APPENDIX E
COORDINATION DOCUMENTATION

APPENDIX E
List of Correspondence and Other Documentation

SUBJECT: Jim Woodruff Interim Operations Plan – Meeting with US Fish and Wildlife Service to Discuss Compliance with Terms and Conditions of the Biological Opinion

Figure 19 (BiOp Figure 4.2.3.B): Max Habitat Sustained for At Least 30 Days During Spawning

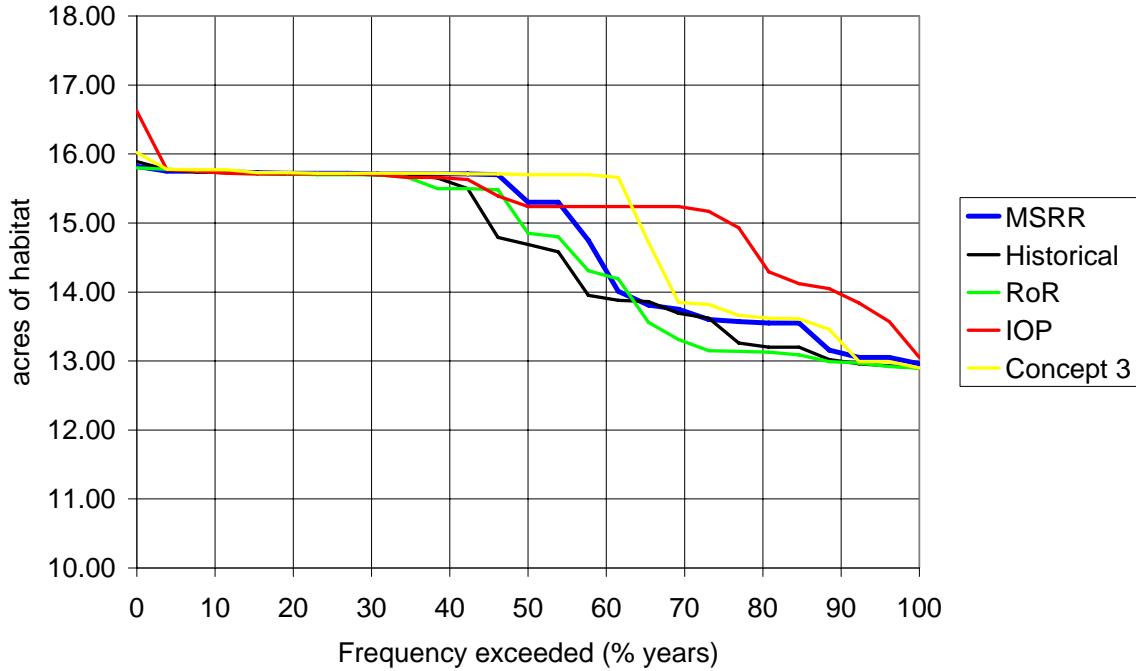
The next performance measure, Figure 19 (BiOp Figure 4.2.3.B), shows the maximum amount of habitat sustained for at least 30 days during spawning season each year. The IOP performs somewhat better than the other traces on this measure. The increase in sustained habitat, however, is at most about 1.5 acres, which is not likely to significantly affect such a small population of spawning fish. Furthermore, the changes planned to the IOP by the USACE illustrated by Concept 3 reduce the advantage of the IOP on this measure. The MSRR provides more sustained habitat than the Baseline or RoR, signifying no impact to the sturgeon based on the BiOp criteria. Finally, the performance on this particular measure is greatly influenced by the bathymetry at RM 99.5, the location at which very few eggs have been collected compared to RM 105.

Figure 25: Frequency of Stages at Lake Lanier

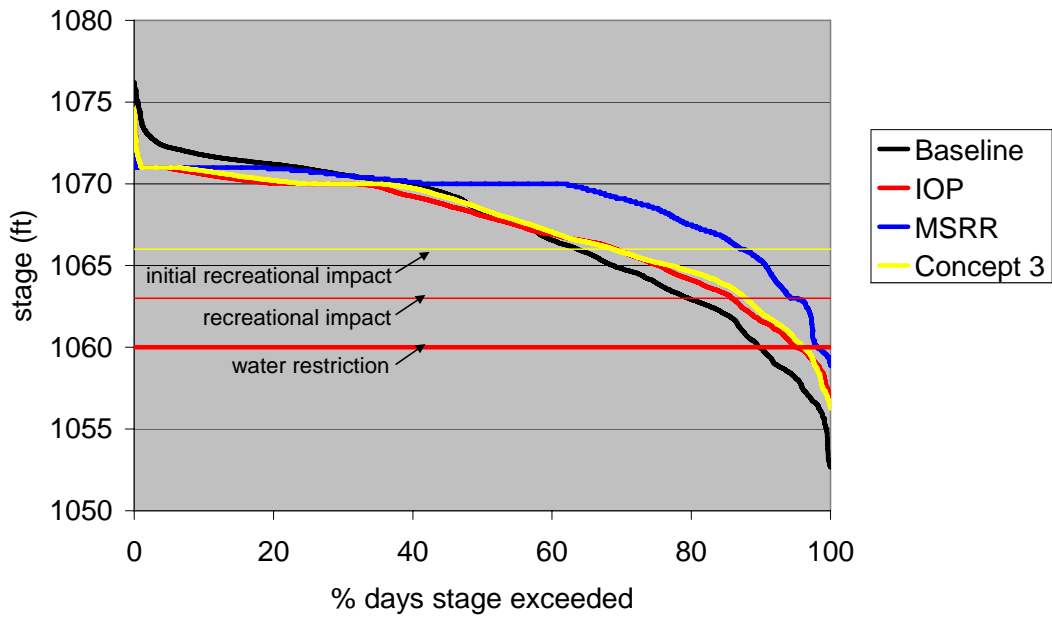
Finally, and perhaps most telling is ARC's analysis of the impact its plan might have on Lake Lanier. ARC Plan at 40, Figure 25 Frequency of Stages at Lake Lanier. It is clear from this Figure ARC views any scenario that reduces the elevation of Lake Lanier to less than 1059' as one that must be avoided. ARC's analysis concludes that *even in the worst case scenario*, Lake Lanier would remain at or above this elevation. Such a floor has no foundation in law, is well over the historic low elevation of 1053' and is 11' above municipal and industrial supply intakes. Clearly, ARC's fundamental objective is to elevate recreational and municipal and industrial uses above the needs of the Apalachicola River species. But, ARC has it backwards. In *Tennessee Valley Authority v. Hill*, 437 U.S. 153, 194 (1978), the Supreme Court emphatically explained that "Congress has spoken in the plainest of words, making it abundantly clear that the balance has been struck in favor of affording endangered species the highest of priorities"

Figure 3--Quarterly Flow at the Chattahoochee Gage by Year for 1939-2006

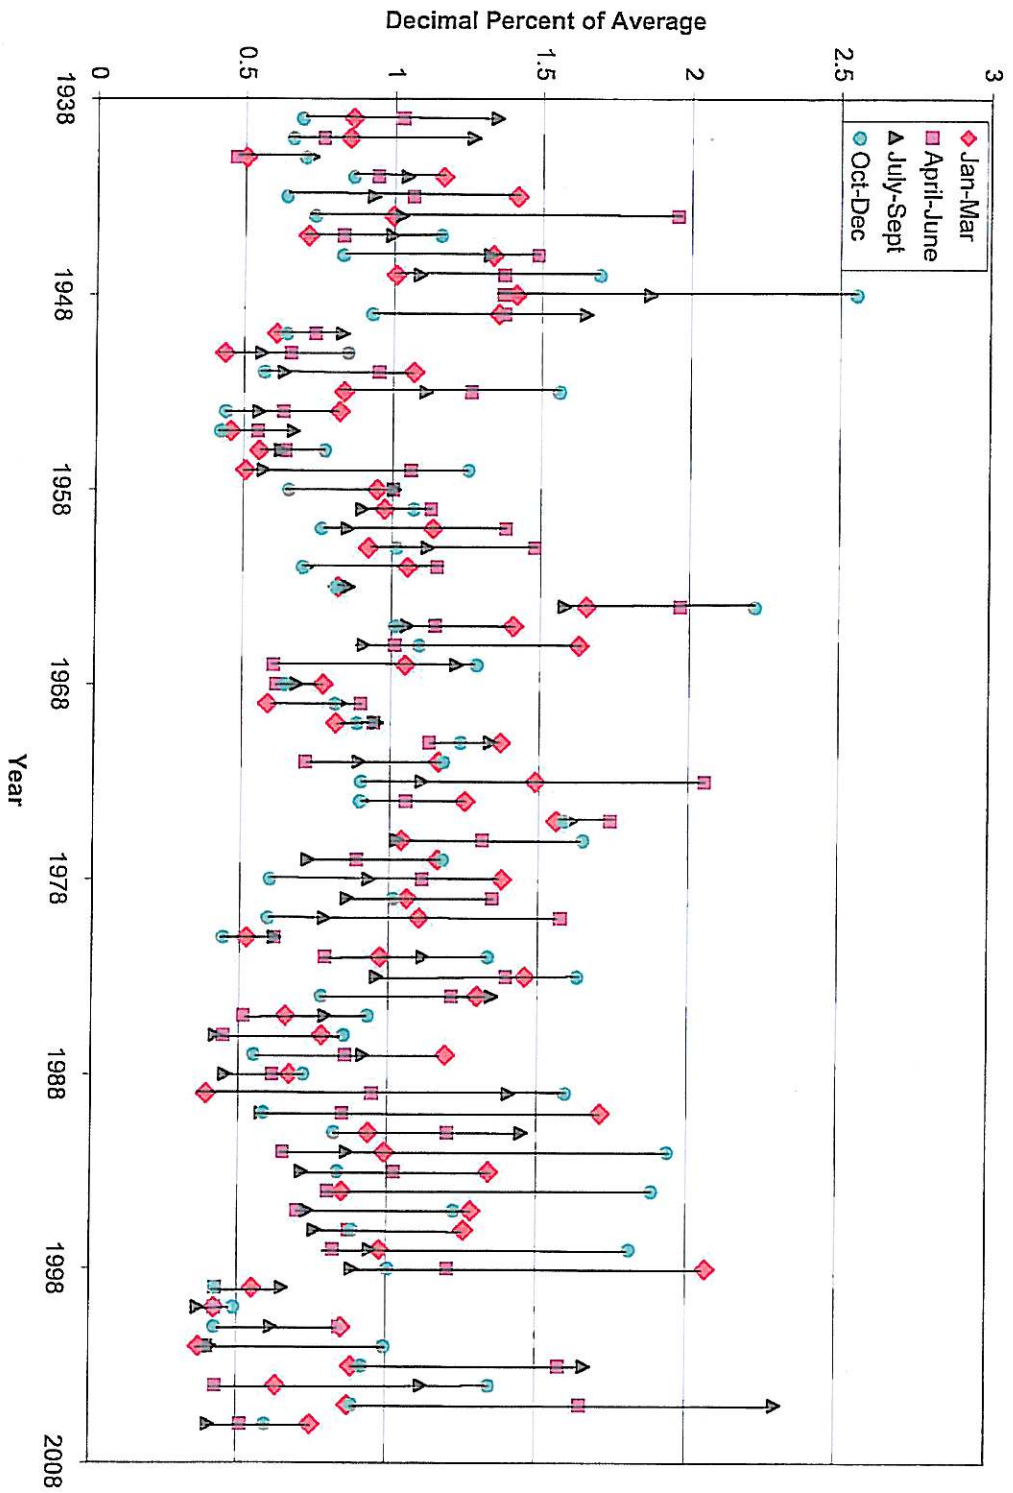
Florida also analyzed the temporal variation in flow to determine if conditions early in the year (January to March) were a reliable predictor of conditions for the remainder of the year. **Figure 3** illustrates the quarterly observed flows at the Chattahoochee gage for the period 1939 to 2005 expressed as the ratio to the quarterly average flow. For example, if the observed value is identical to the average, the ratio will be exactly 1 (i.e., the observed flow is 100% of the average). Values less than 1 are instances in which below average flow was observed. Values greater than 1 are instances in which the observed flow is greater than the long-term average.

Figure 5--Quarterly Flow at the Chattahoochee Gage by Year for 1939-2005
 (Years when Jan-March flow is 55% of Average or less)

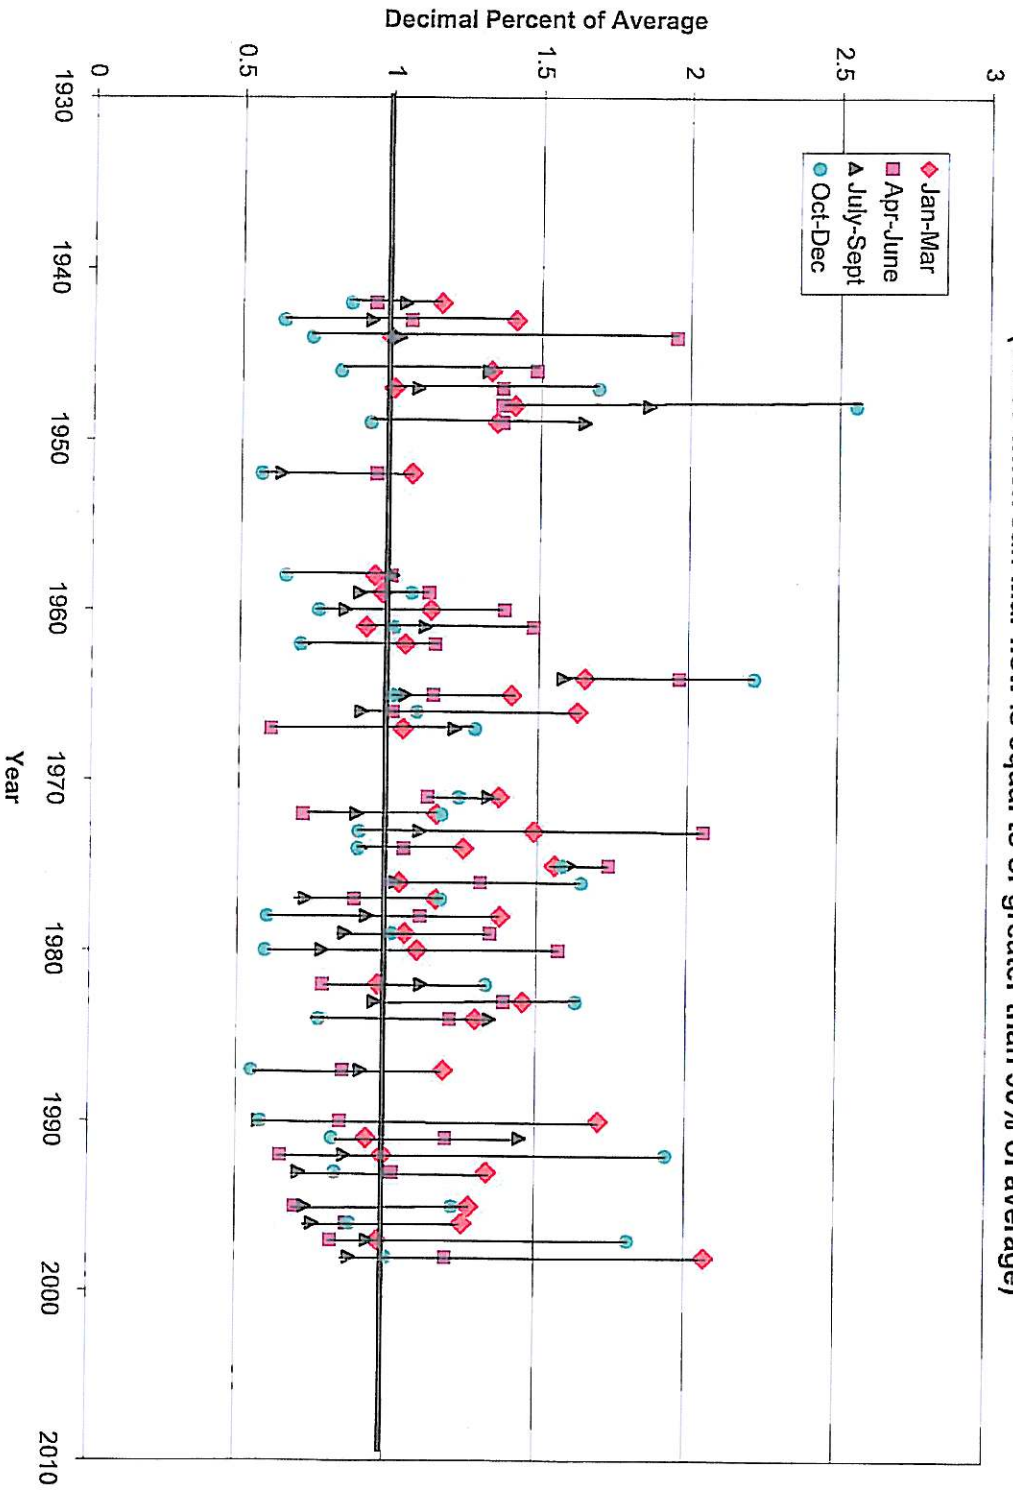
In contrast, if the January - March flow is only 55% of normal or less, then there is a very high probability that severe drought and low flow conditions will occur during the dry season. This condition occurred in 10 of the 67 years (**Figure 5**). All the most severe droughts of record occurred in years in which the January - March flows were 37% to 55% of normal (**Figure 4**). This condition occurred in 1981, 1999, 2000 and 2002 without

Figure 6--Quarterly Flow at the Chattahoochee Gage by Year for 1939-2005
 Years when Jan-March Flow is 55% to 90% of average

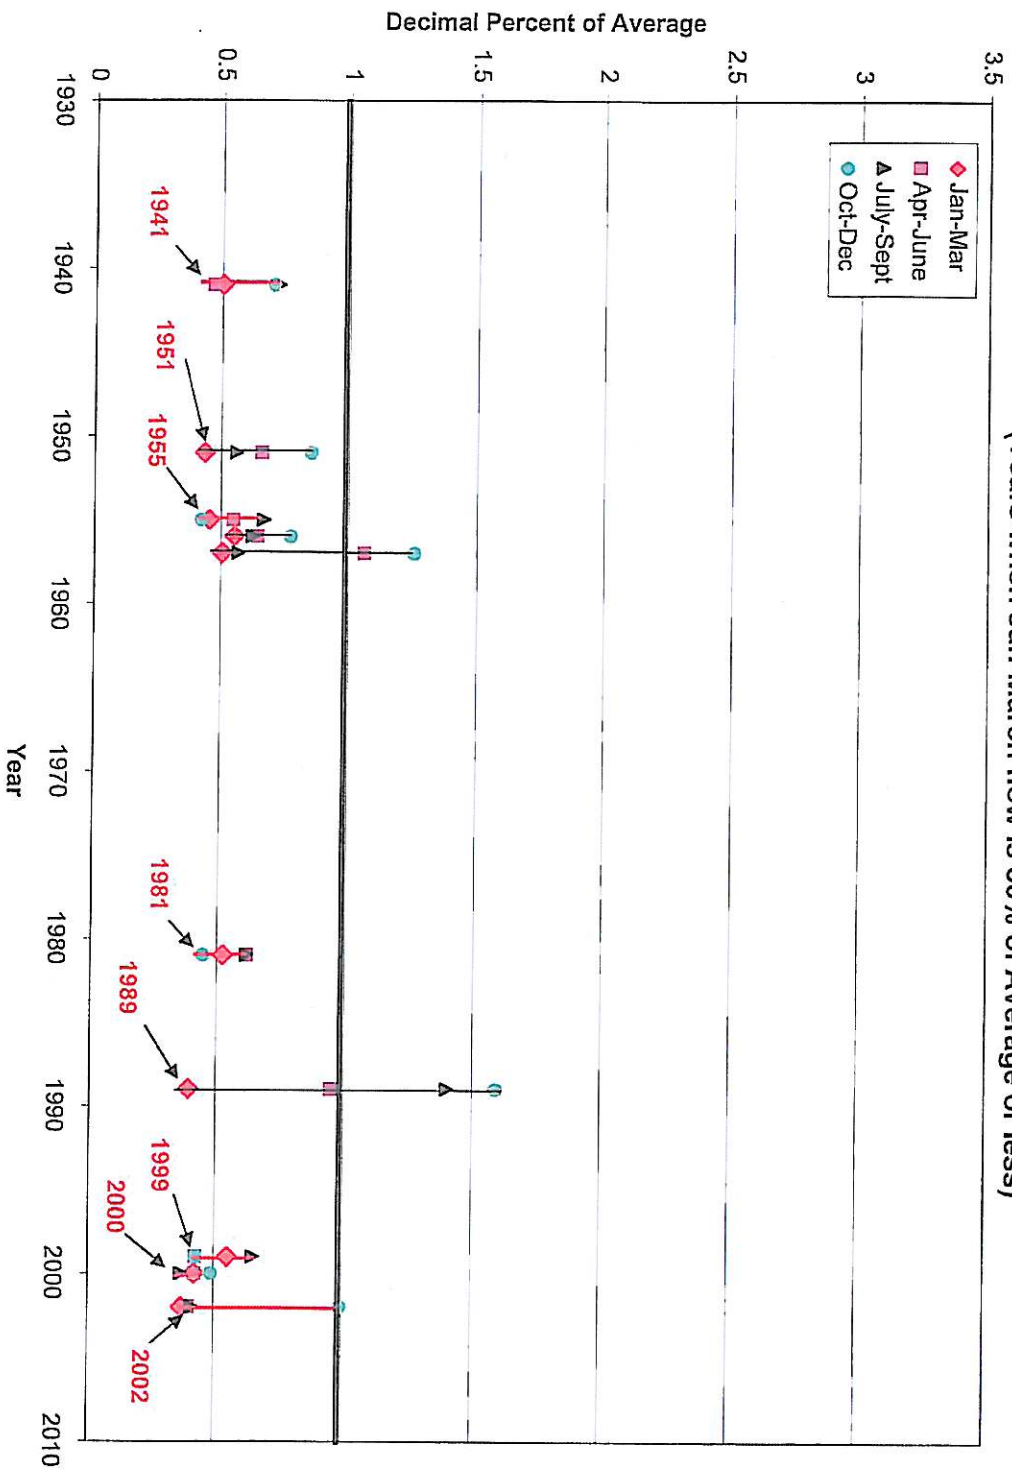
Of the remaining 18 years in which the January - March flow at Chattahoochee was between 55% and 90% of normal, 12 were years that were not persistently dry (Figure 6), and in which there were no operational problems, abnormally low reservoir levels or low flows at the state line. The remaining 6 years include 1950 and 1954 (pre-reservoirs), 1968, 1986, 1988, 2001 and 2004. These were dry years, but did not result either in severe low flows for an extended period of time or low levels at Lanier.
